ALAMEDA COUNTY  
HEALTH CARE SERVICES

Subject: Spills, Leaks, Investigations and Cleanup (SLIC) case file #RO0002863, Crow Canyon Cleaners, 7272 San Ramon Road, Dublin, CA

Subject: SLIC Case No. RO0002863, Crow Canyon Cleaners, 7242 San Ramon Road, Dublin, CA – Work Plan Approval

Subject: Toxics Case No. RO0002863, Crow Canyon Cleaners, 7242 San Ramon Road, Dublin, CA – Request for Work Plan

Revised Figure 3

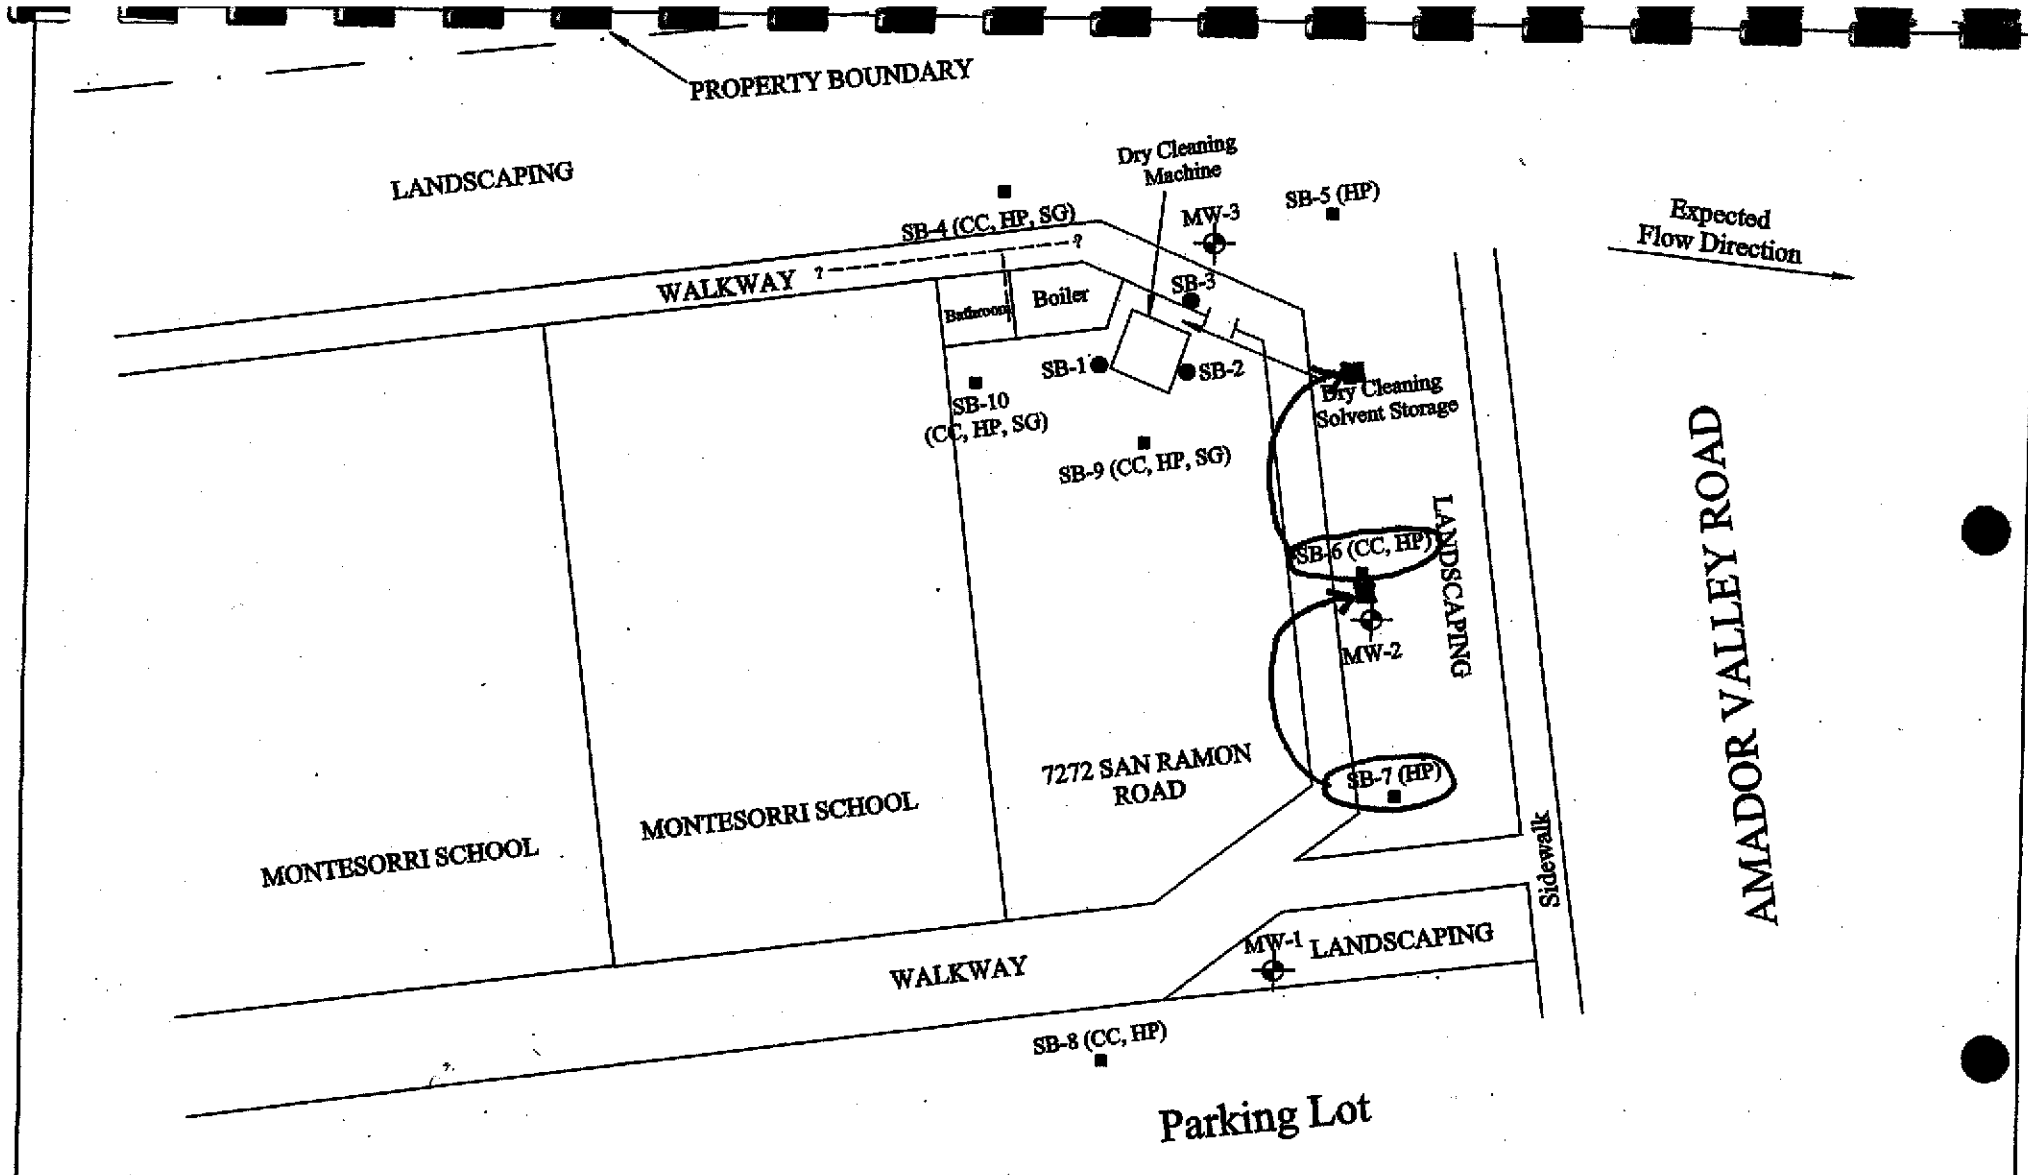
- 1. Base Map.** The base map (Figures 2 and 3) for the site currently shows Amador Valley Road trending in a north-south direction east of the site. Amador Valley Road is a generally east-west trending road. Please correct or revise the base map accordingly.

- 2. Proposed Boring Locations.** Based on local topography, the expected groundwater flow direction is to the east southeast. ACEH requests that proposed soil boring SB-6 be located directly downgradient from the suspected source area as shown on the attached Revised Figure 3. The proposed location for boring SB-7 should also be moved to the north to compensate for the revised location of boring SB-6.

Alameda County Environmental Health (ACEH) staff has reviewed the fuel leak case file for the above-referenced site and the document entitled, "Site Investigation Work Plan," dated November 21, 2005, prepared on your behalf by AEI Consultants. The work plan proposes a scope of work to collect and analyze soil, groundwater, and soil vapor samples from 7 borings. ACEH concurs with the proposed scope of work provided that two of the proposed boring locations are moved as shown on the attached Revised Figure 3 and discussed in the technical comments below.
